## TECHNICAL MEMORANDUM

**FILE NAME:** Euclid House RUE

**PROJECT NO.:** PLN51139 RUE

**SUBJECT:** Summary of RUE Alternatives Assessment & Comparison  
Notice of Complete Application-Related Site Development Alternative

FIGURE 1 – PROPOSED SITE DEVELOPMENT PLAN WITH CROSS SECTIONS

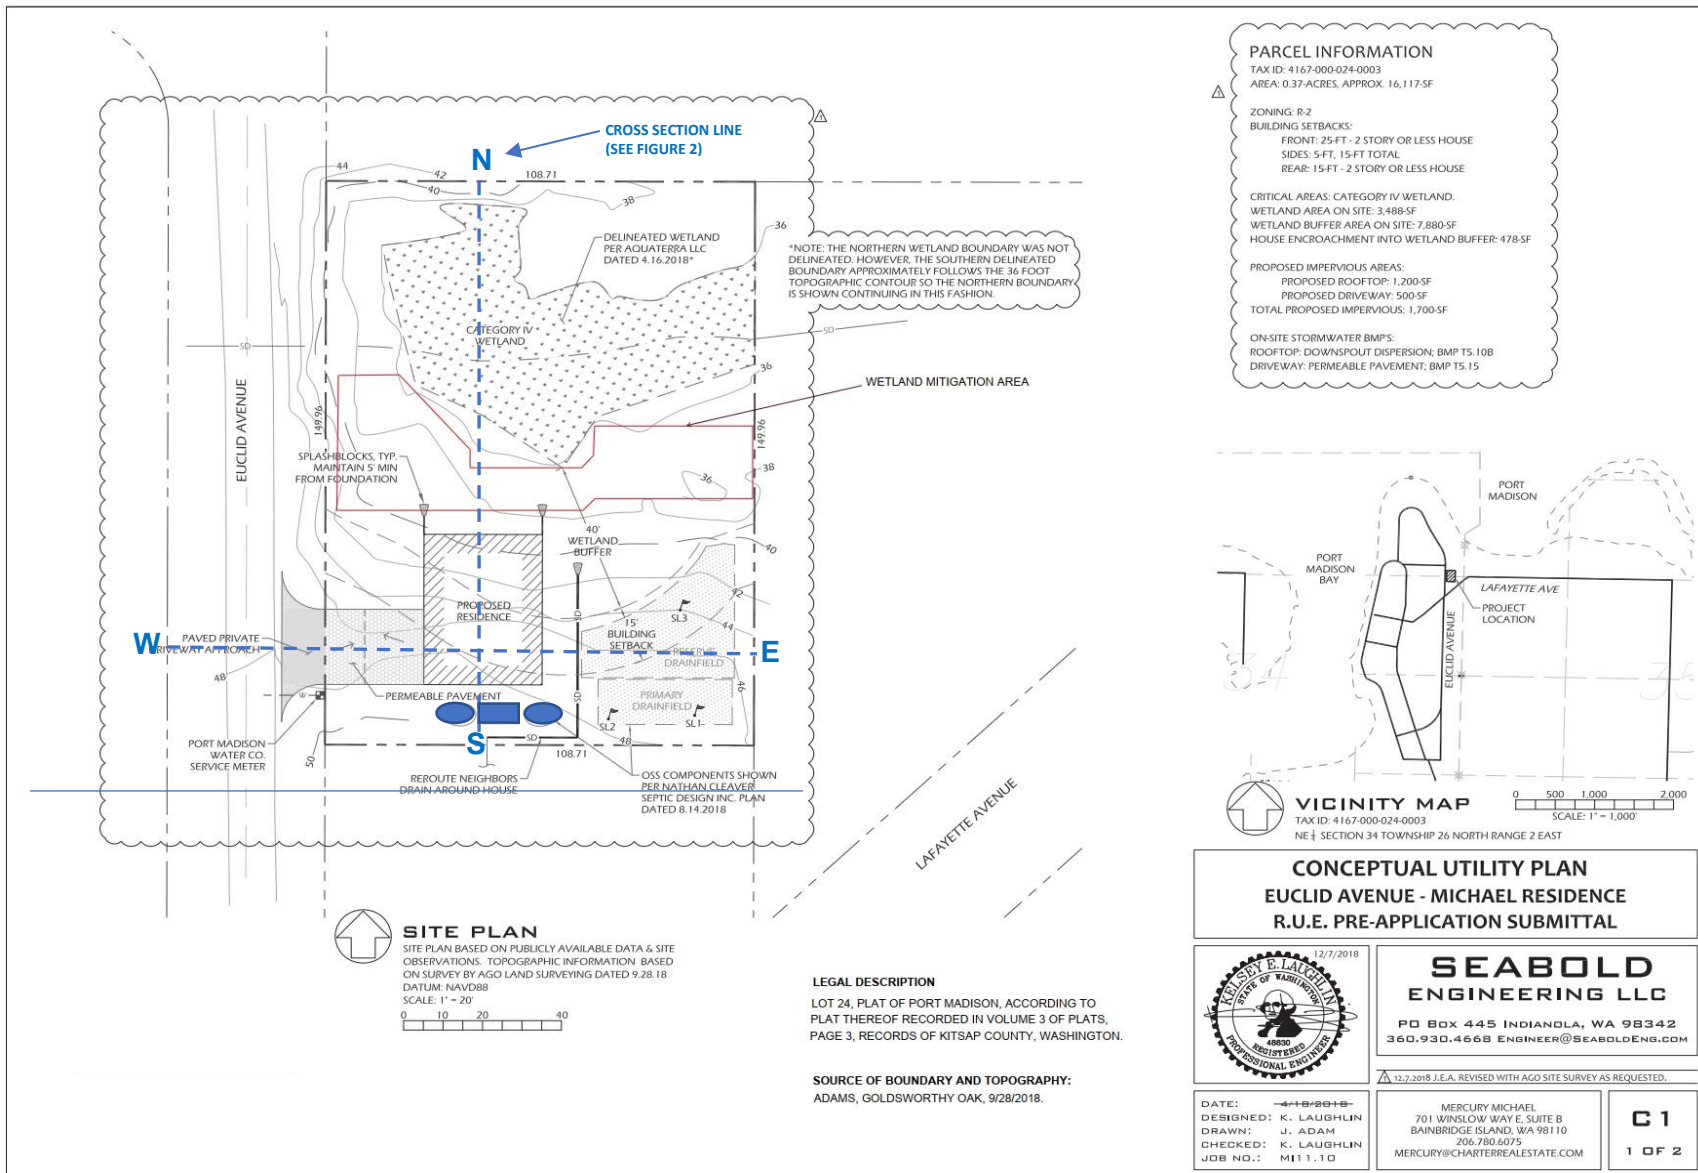
- To minimize adverse impacts to the wetland, the SFR is proposed to be constructed in the southwestern corner of the parcel (Figure 1). The house would be cantilevered from the street level utilizing the pin piles or piers, creating a 10 to 12 feet vertical separation from the ground surface (Figure 2) with no stairway or other direct access to the wetland mitigation area, wetland buffer and wetland, which would prevent encroachment and demonstrate compliance with RUE review criteria 3 and 4 to the extent practicable considering the site constraints.

The need for the OSS system creates several challenges in terms of the proposed site development. Due to site constraints associated with the wetland-related buffer, topography, and soil conditions, the OSS would require a buried pressurized system that would include two tanks and mechanical components consisting of wastewater treatment and air blower, in addition to the drainfield. The OSS-related tanks and mechanical system cannot be realistically installed on a slope without fill placement due to the need for vehicle access for maintenance and possible repair after installation. Therefore, these components are proposed to be installed between the SFR and southern property boundary, as highlighted on Figure 1. The OSS tanks and mechanical system installation would be at or near the existing site grades.

The 16-foot wide alleyway created by the underground OSS tanks and mechanical system would also allow for vehicle and equipment access to the primary and reserve drainfields for maintenance and possible repair after installation (Figure 1), as well as provide a critical staging area during the construction of the SFR.

FIGURE 3 – SITE DEVELOPMENT LAYOUT AS RECOMMENDED IN NOCA

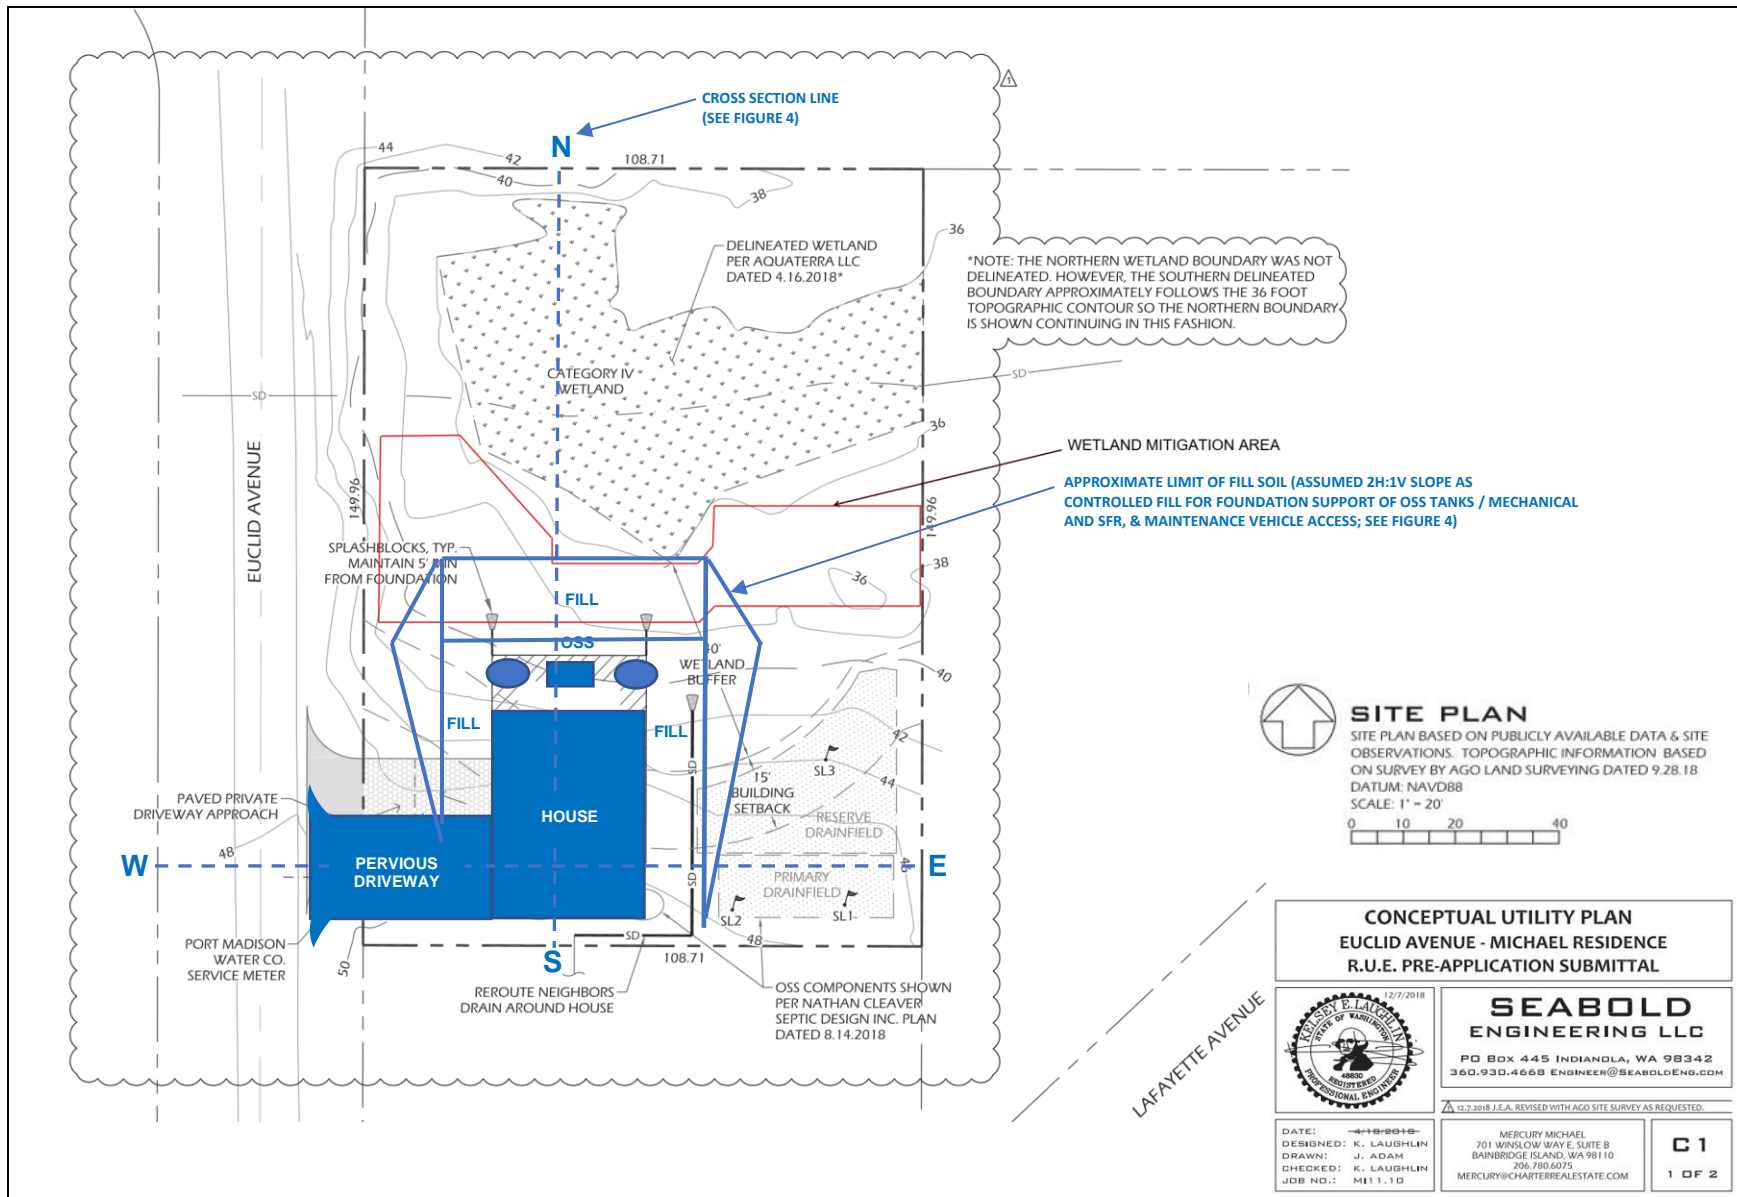
As described in the above-mentioned NoCA, and as shown on Figures 3 and 4, the recommended alternative to the site development layout includes reversing the SFR and OSS in the north-south orientation, with the SFR setback the minimum 5-foot distance from the southern property boundary/lot line, and the OSS situated north of the SFR. The intent was to:

- Allow for the standard impervious surface setback between the SFR and the wetland mitigation area edge, with the OSS tanks and mechanical components located between the SFR and the wetland mitigation area edge, and to help prevent future encroachment into the wetland mitigation area.
- Provide a construction staging area within the 15-foot impervious surface setback area.
- Improve on compliance with RUE criteria 3 and 4 as presented in the BIMC 16.20.080<sup>3</sup> by placing lower impact development (i.e. buried septic tanks and mechanical components) with vegetation/lawn at the ground surface within the wetland buffer and closest the wetland edge.

The alternative as presented in the NoCA would be feasible and likely achieve the above-mentioned intent if the subject parcel was flat lying with minimal topographic relief. However, due to the roughly 12 feet of topographic relief the alternative would require on the order of 700-plus cubic yards of fill soil placement within the wetland buffer and mitigation area, and possibly encroach upon the wetland<sup>4</sup>. Therefore, the mitigation area would be reduced in size by roughly 30-plus percent.

In summary, the alternative recommended in the NoCA would be feasible and effective at achieving the intended outcomes if the site was flat lying. However, when the site topographic relief is considered the alternative would likely result in significant adverse impact to the wetland due to the need to add significant quantities of fill soil and/or retaining walls. The alternative would likely not comply with RUE criteria 3 and 4 as intended.

**FIGURE 4 – CROSS SECTIONS OF SITE DEVELOPMENT AS RECOMMENDED IN NOCA**

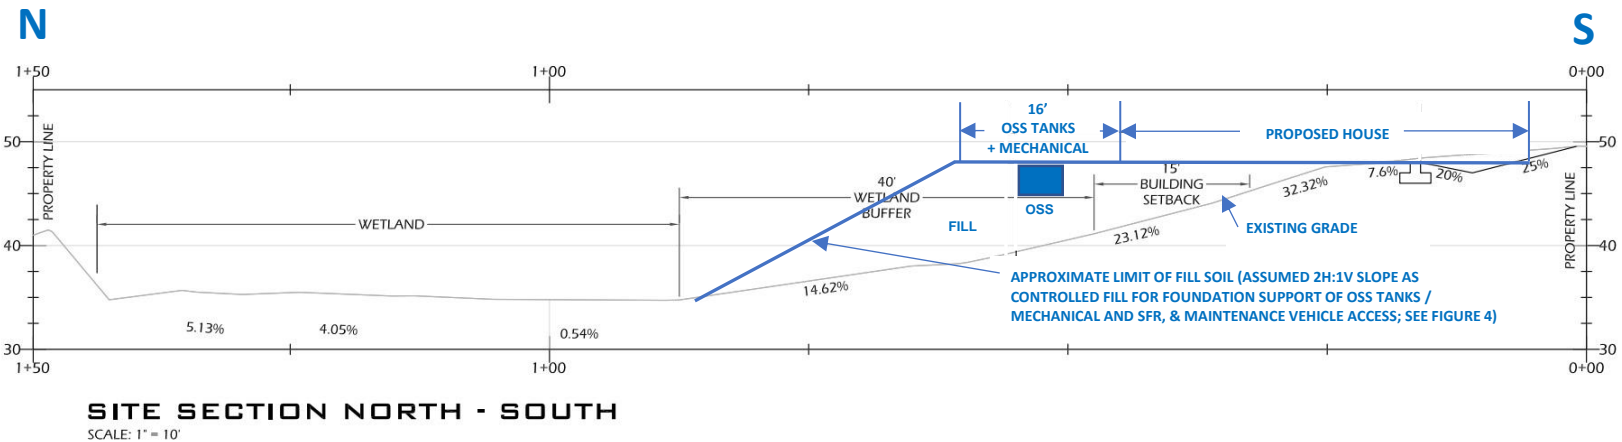
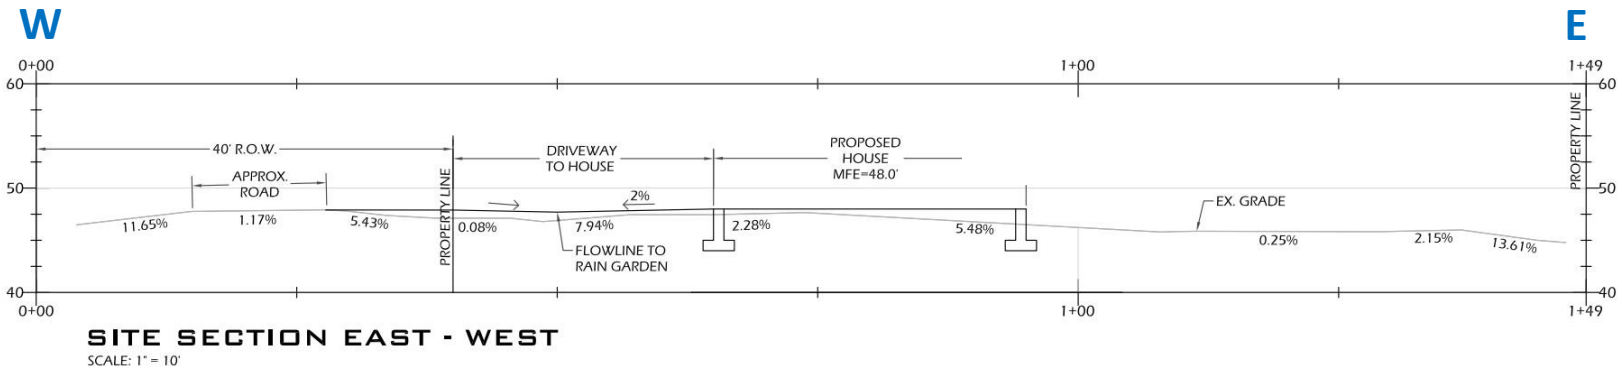
The fill would need to be imported and compacted in order to prevent post-construction settlement and possible damage to the OSS-related piping and prevent erosion.

It may be possible to construct retaining walls to reduce the amount of fill placement, but the retaining walls and related fill soil placement would need to occur within the wetland buffer and reduce the size of the mitigation area.
